RE: Progress Energy Florida – Levy Nuclear Project Units 1 and 2  
DOAH Case No. 08-2727; DEP OGC Case No. 08-1621; PPSA No. PA08-51  
DETERMINATION OF INCOMPLETENESS (*Main Site & Associated Facilities*)

Please find enclosed four copies of Progress Energy Florida's responses to the "Determination of Incompleteness – Main Site & Associated Facilities" for the Levy Nuclear Plant.

# Responses to Comments on Levy Nuclear Plant Units 1 and 2 Site Certification Application for Power Plant and Associated Facilities

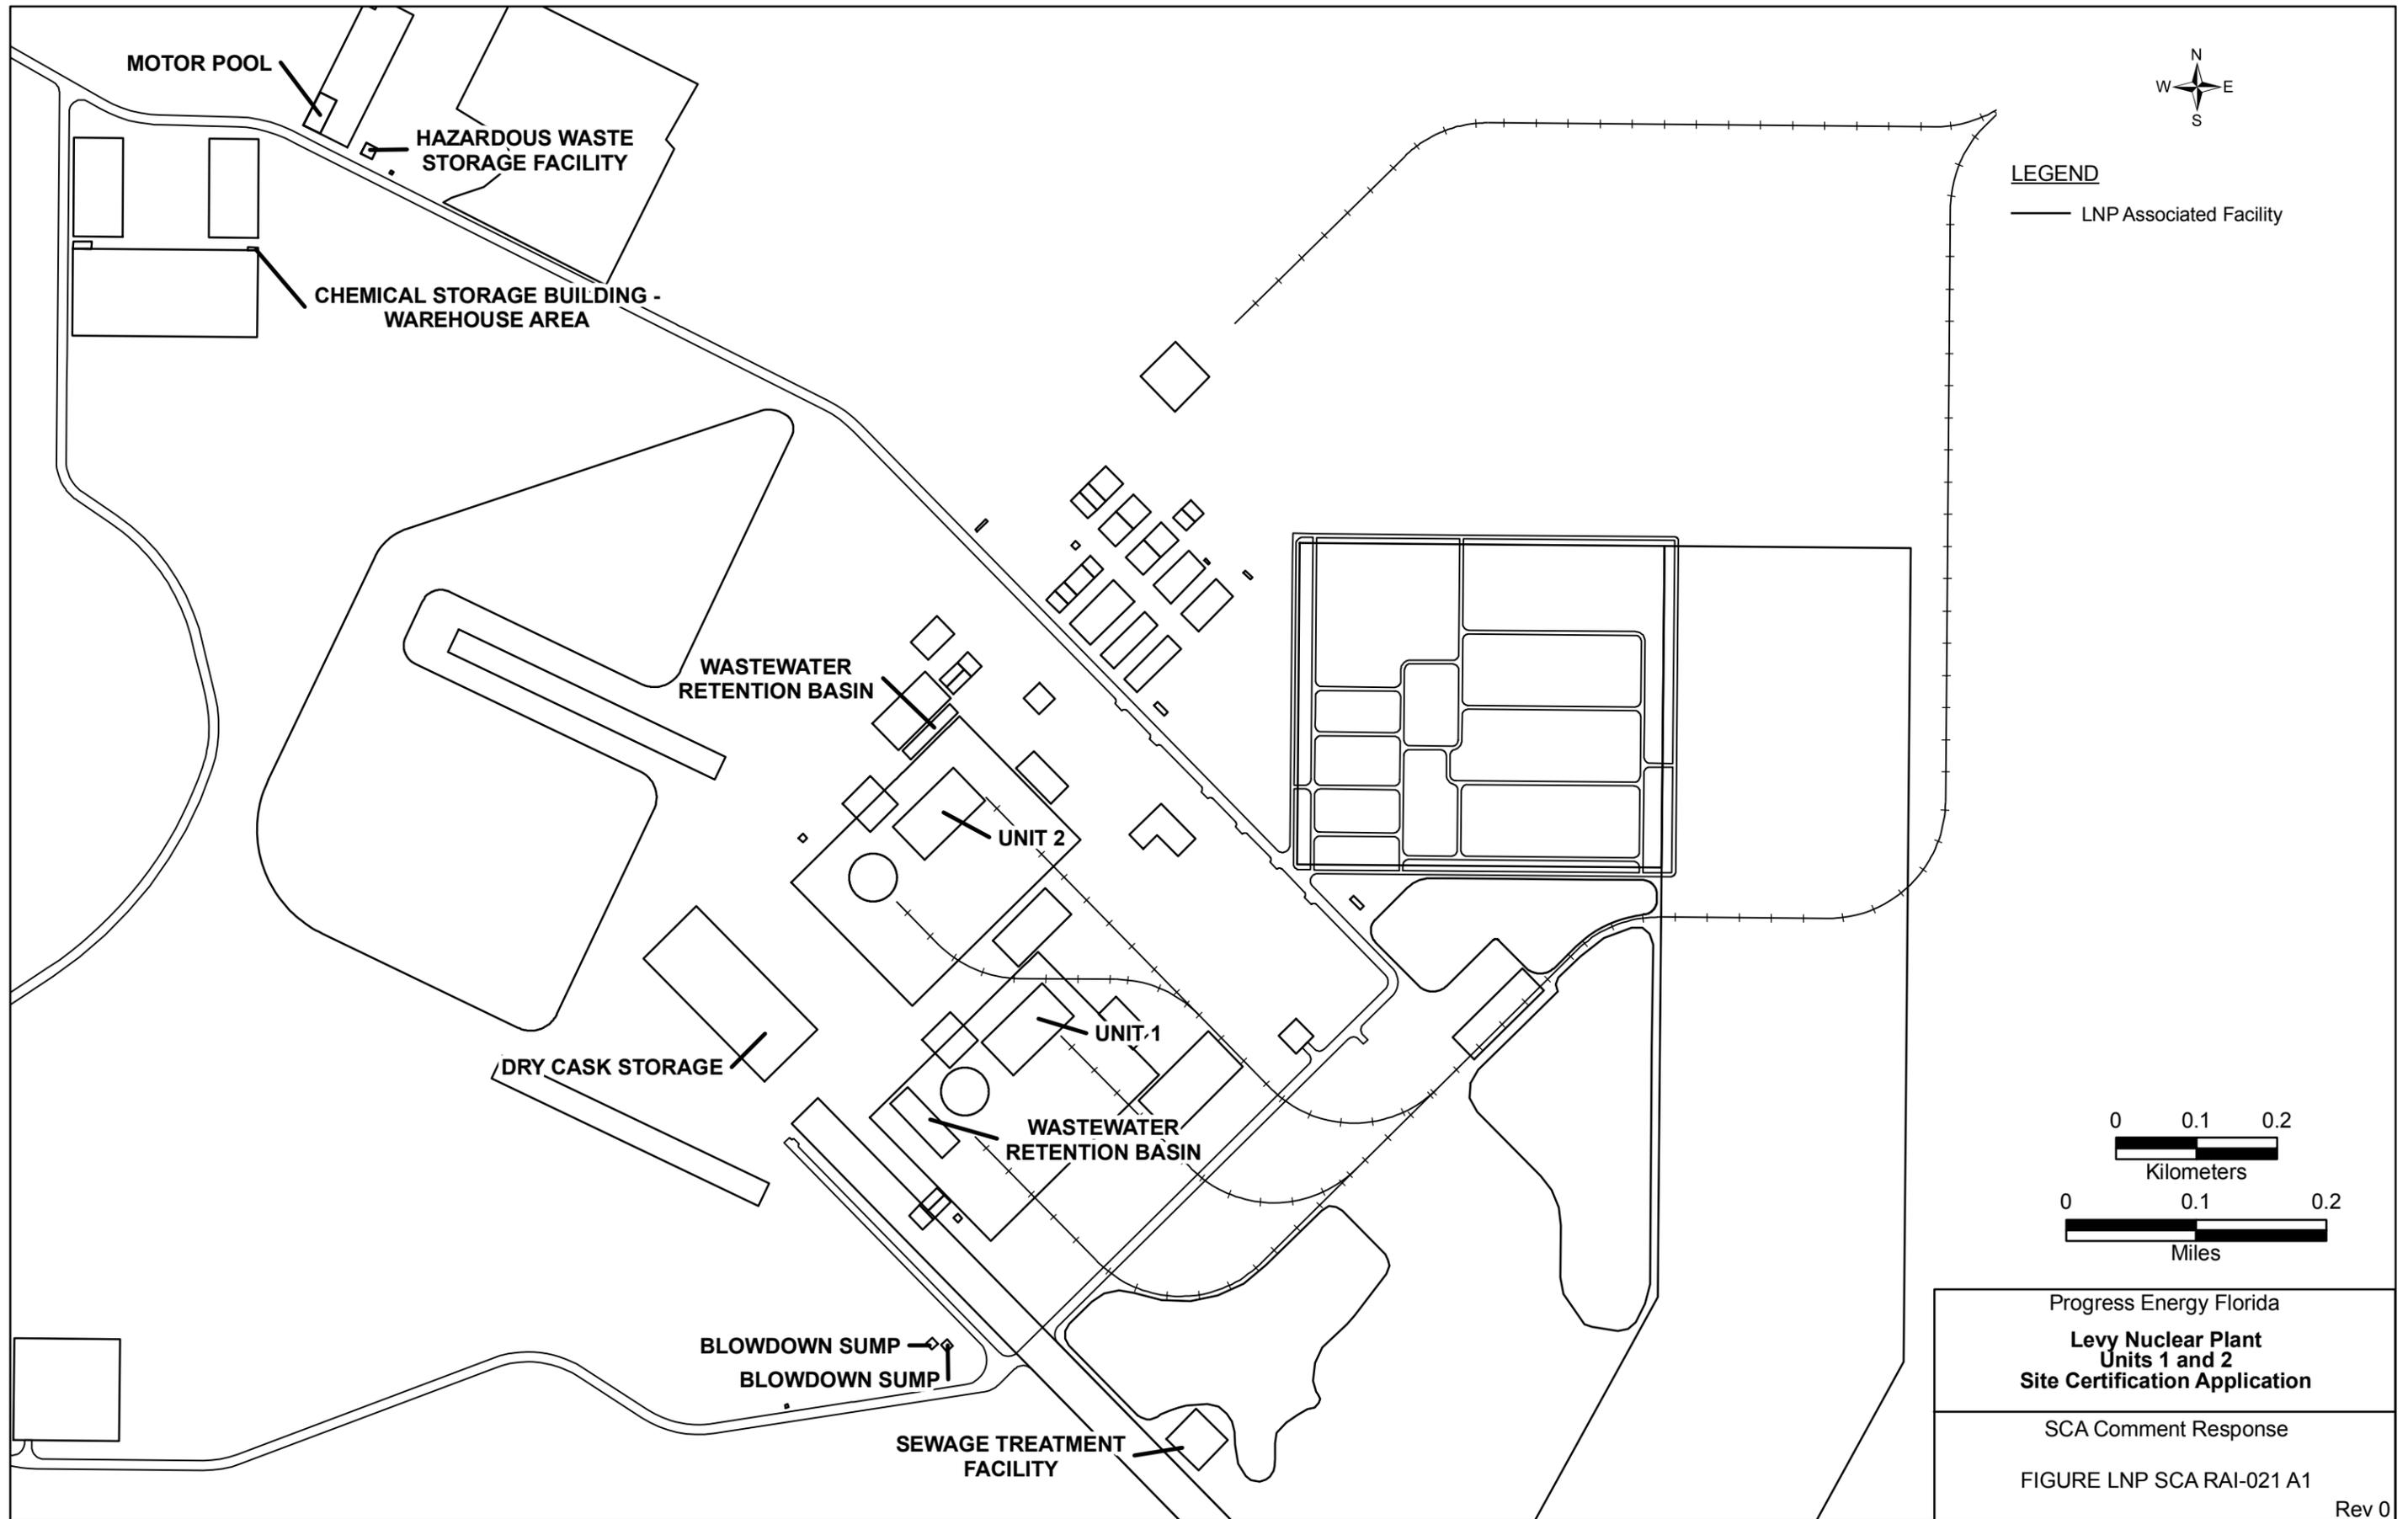
A suitably scaled site plan (maximum 11" x 14") is requested that clearly identifies the locations of all discharge and disposal areas mentioned in the previous item.

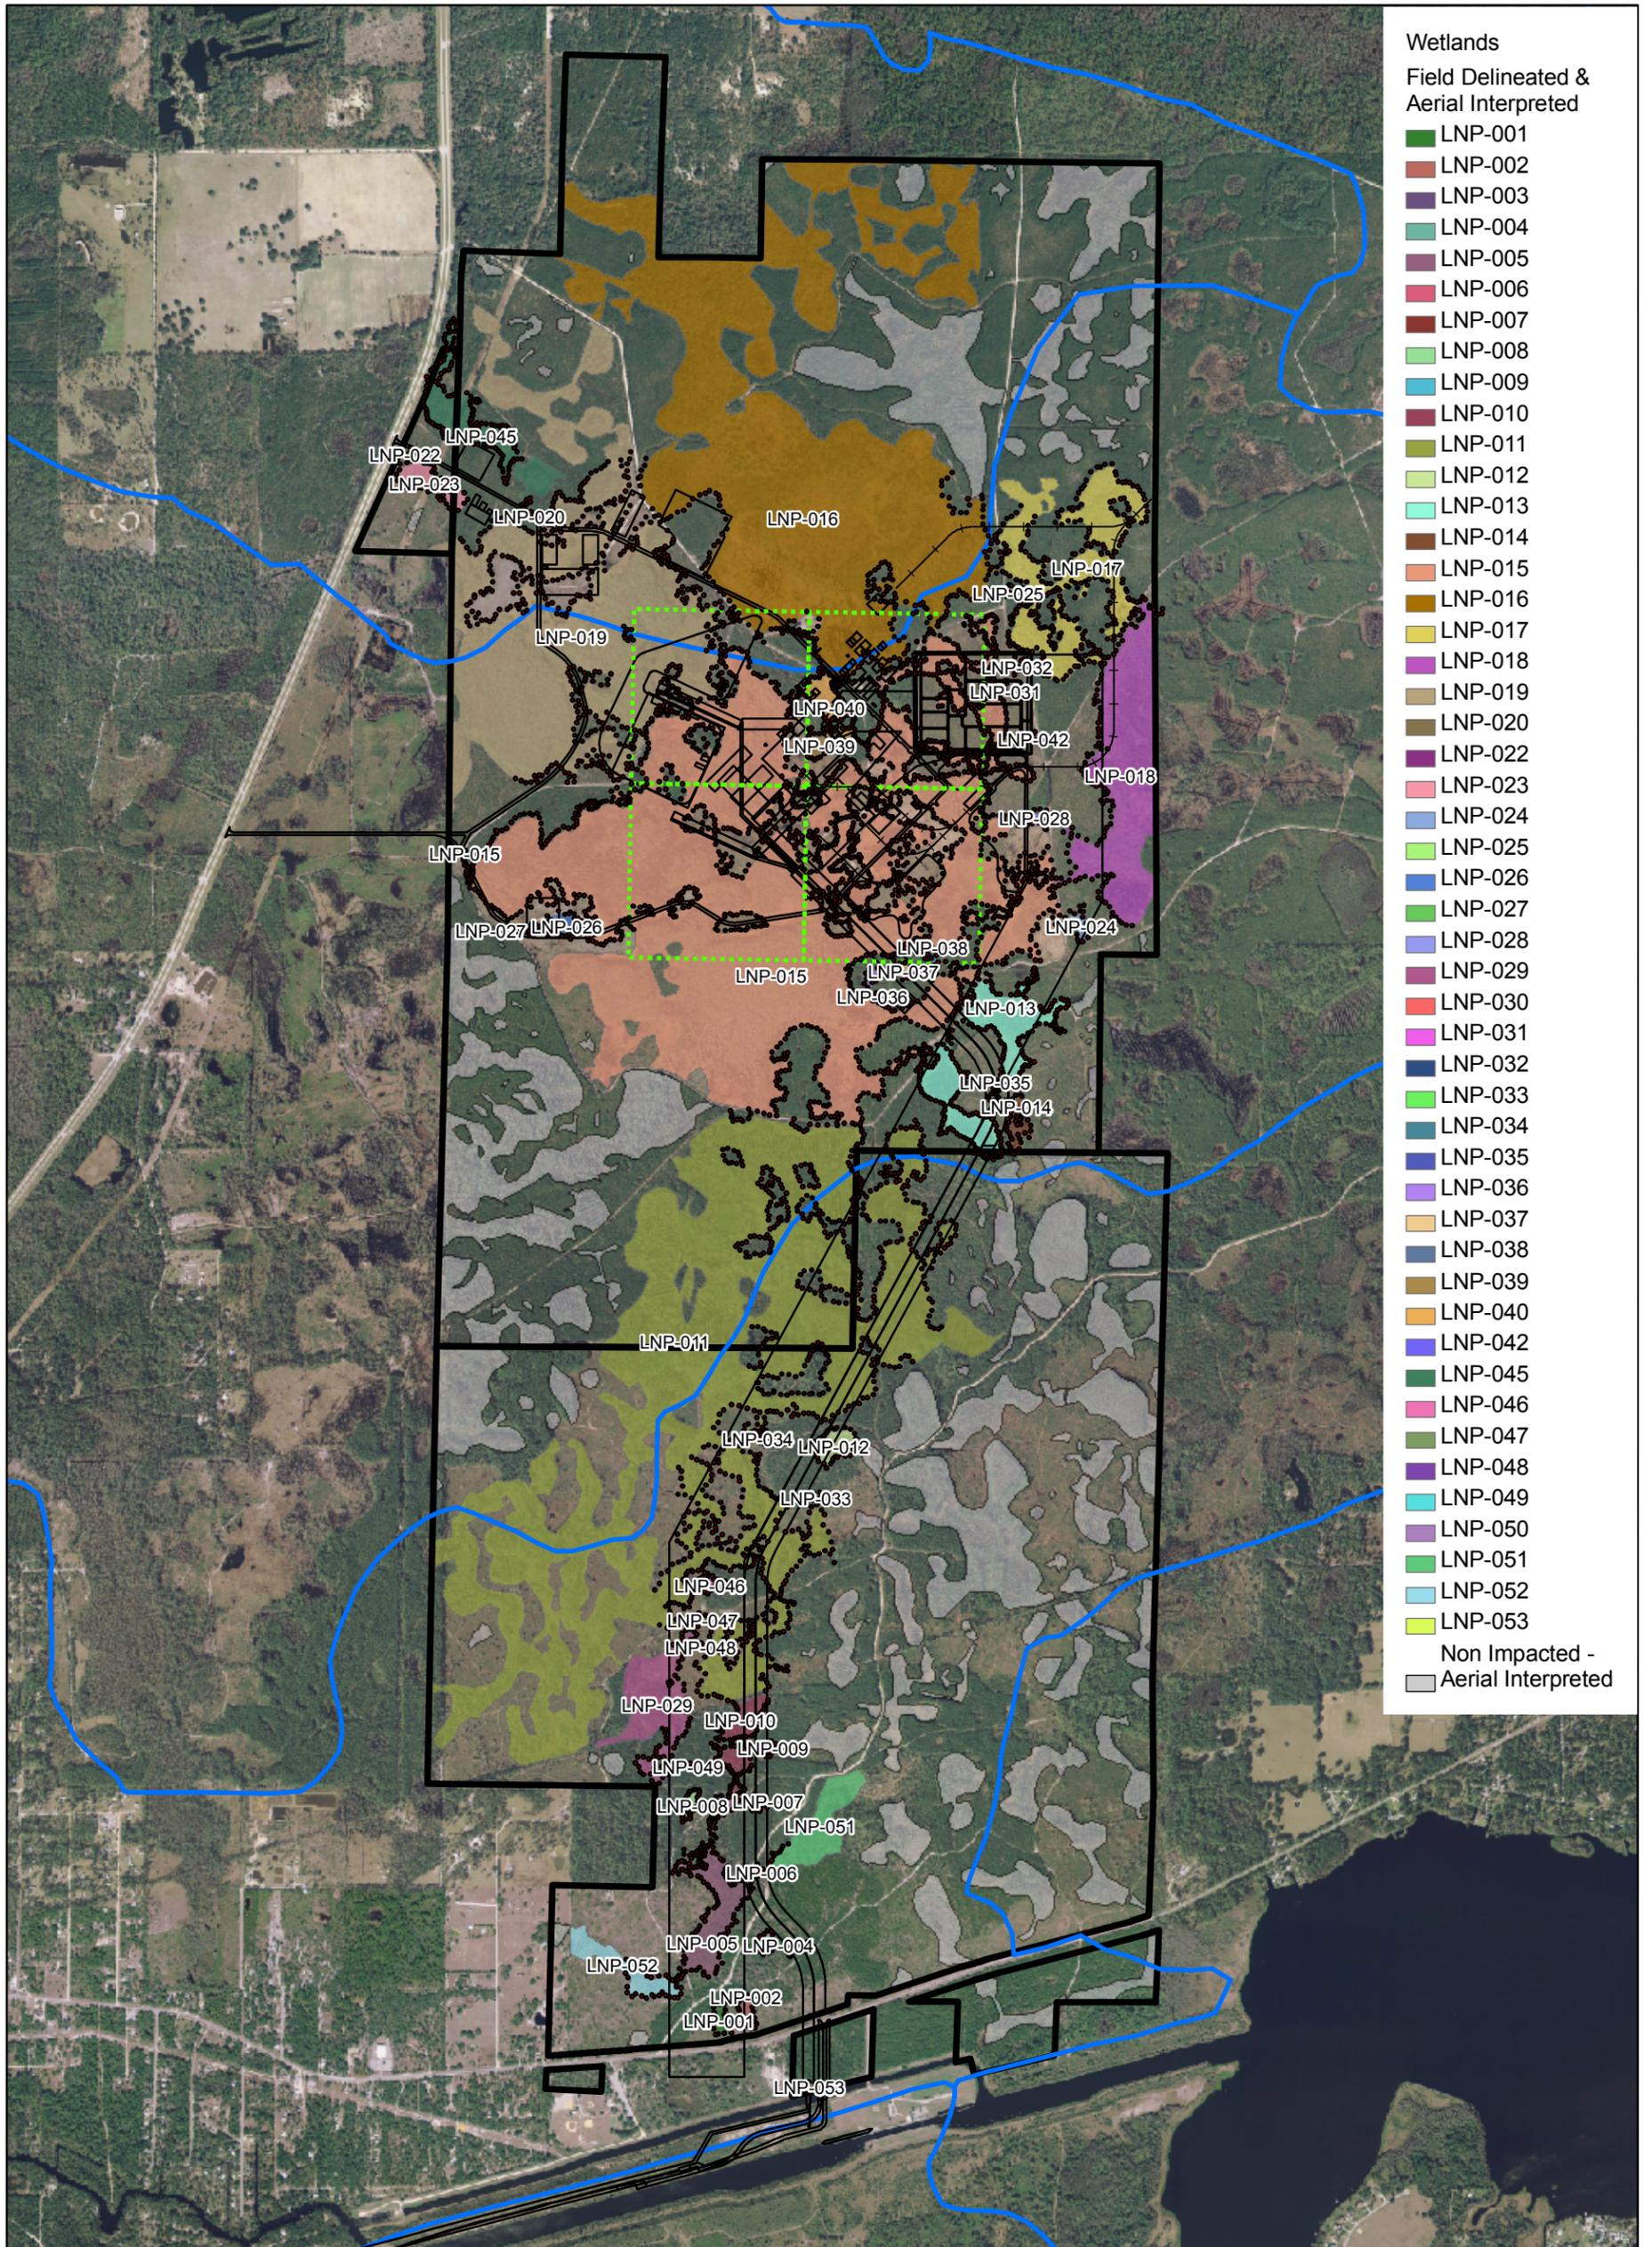
In volume 6 and 7 of the application, are the UMAM scores solely for the impacts associated with the LNP? Or, do the UMAM scores include the pipe line, rail spur, and heavy haul road corridor impacts? Please show the locations of the scored wetlands on an aerial photo and contact Greg Nieboer at (813) 632-7600 for an onsite verification of the UMAM scores. Refer to Chapter 63-345, F.A.C.

The UMAM scores in the ERP application (SCA Volumes 6 and 7) reflect wetlands on the LNP site, the heavy haul road, and those portions of the makeup and blowdown pipeline and transmission corridors located in Levy County north of the CFBC. Locations of these wetlands are shown in the aerial photograph attached. These areas are in the Northeast District of the FDEP, and, in accordance with Siting Coordination Office direction, the Northeast District will be contacted for verification of UMAM scores in these areas.

PEF is seeking certification of corridors for the portions of the pipeline and rail spur located within the boundary of the FDEP Southwest District. As such, specific ROW width and design details will not be finalized until after the corridors are certified. PEF will agree to a condition of certification requiring the post-certification submittal of the detailed design information, to the FDEP, as authorized by Section 403.5113(2), F.S. and Rule 62-17.191, F.A.C.

EXHIBIT 1  
Springs Near LNP Site

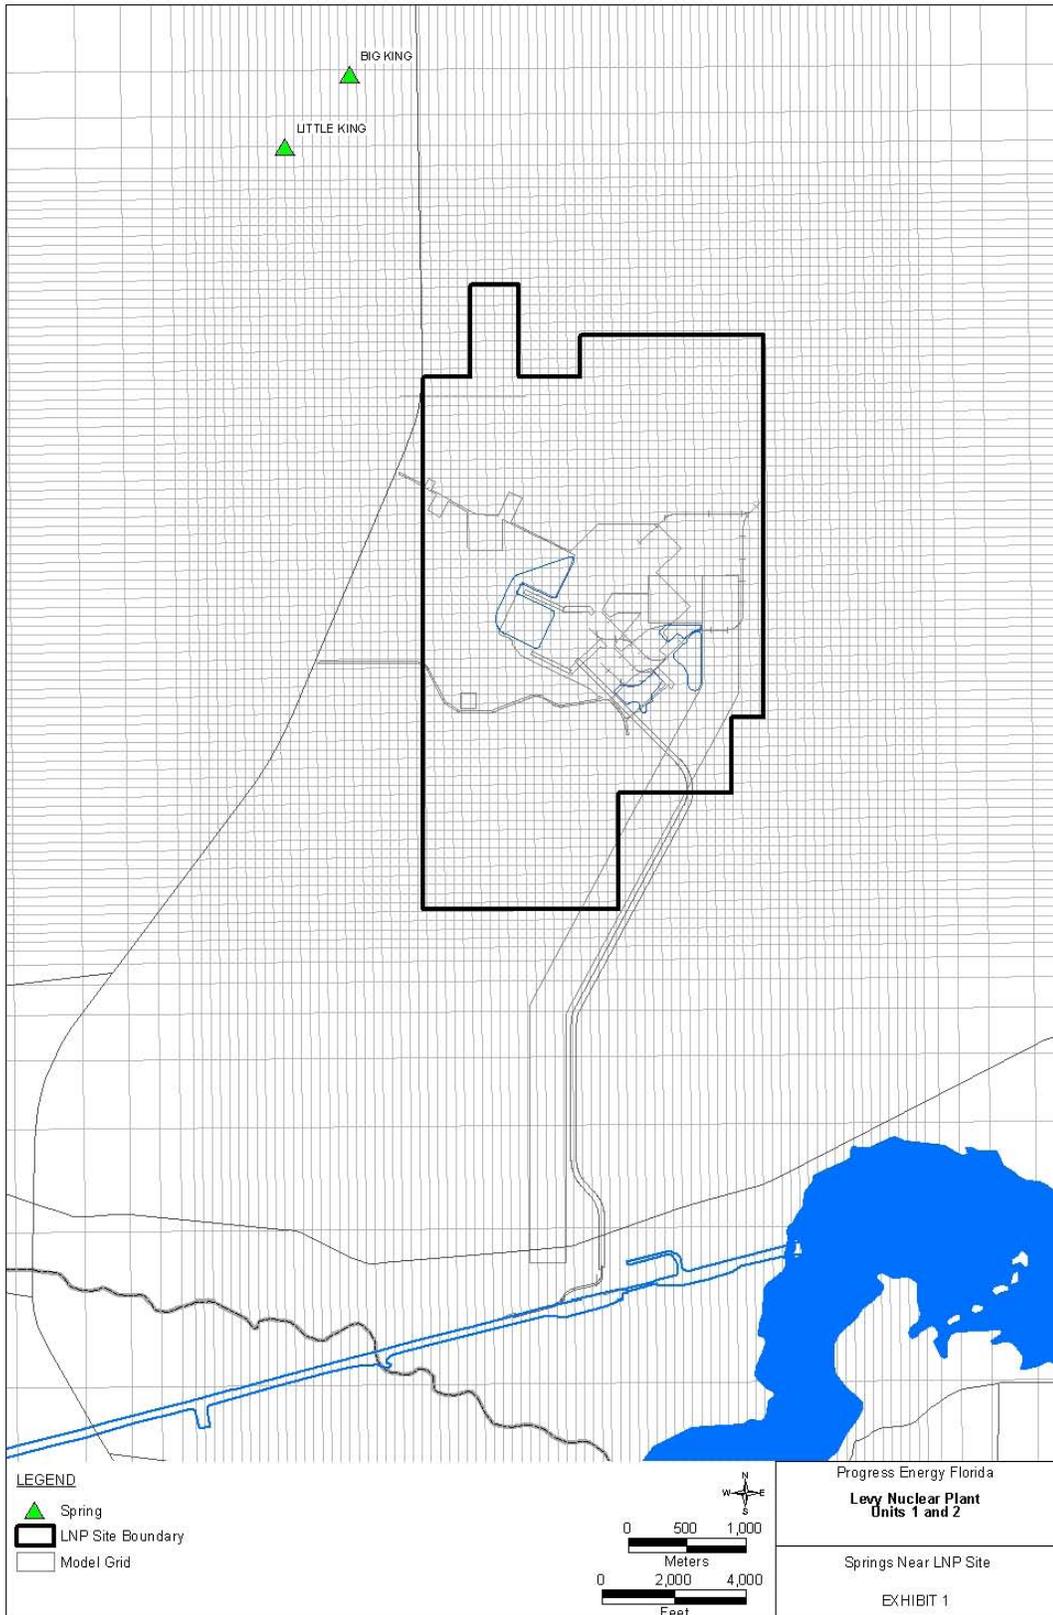
Please provide a scaled location map showing all Class 4 springs, or greater within one-mile of facility property boundary that could be affected by the facility's operations and potential contamination. Figure 2.6-2 shows the Homosassa Springs Dome, and any hydrogeological and chemical issues regarding aquifer connectivity to any springs in the area, and the effects on these springs needs to be addresses.

Exhibit 2 summarizes the details on each spring added to the model.
